STATE OF NEW HAMPSHIRE
DEPARTMENT OF TRANSPORTATION

SALEM TO MANCHESTER
13933G

March 10, 2009

ADDENDUM NO. 1

SK1

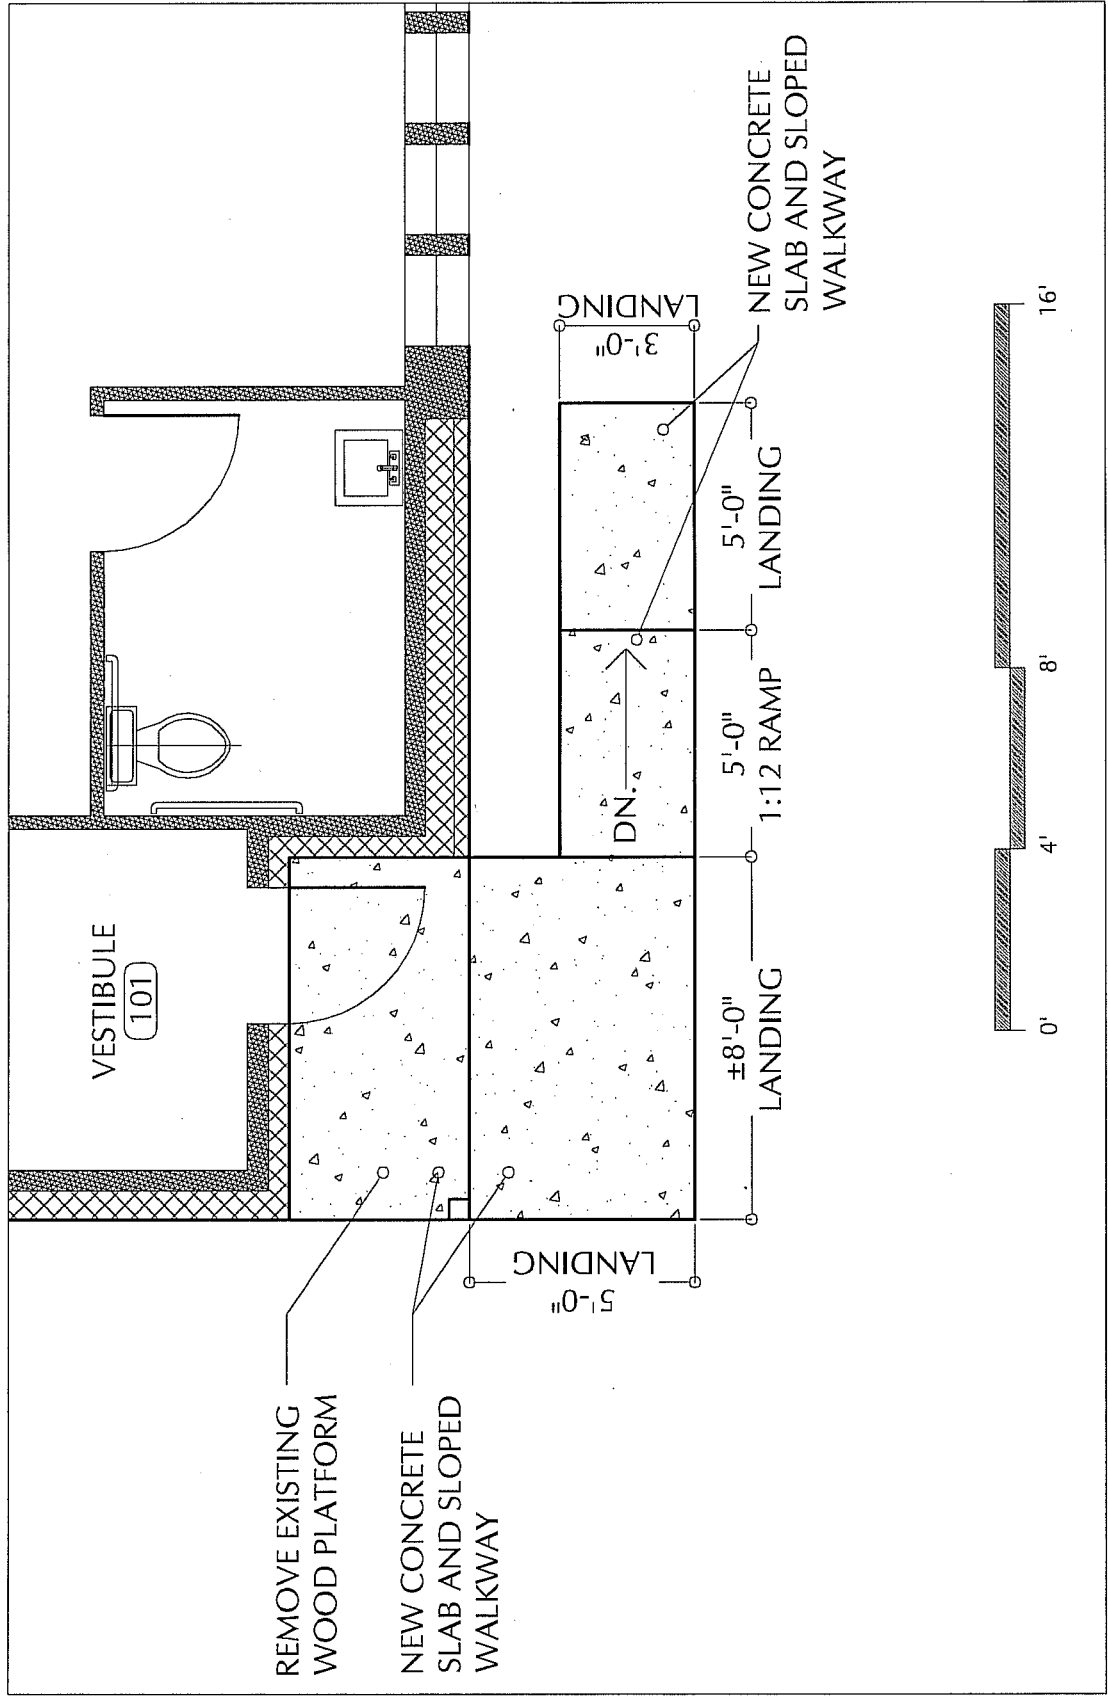
- A.) Provide and install a new concrete entrance pad, sloped walkway, and approach pad as indicated on the attached **SK-1 detail**. Remove and dispose of existing wooden entrance platform.

REMOVE EXISTING
WOOD PLATFORM

NEW CONCRETE
SLAB AND SLOPED
WALKWAY

NOTES:
LOWER LANDING
FLUSH WITH PARKING
AREA.
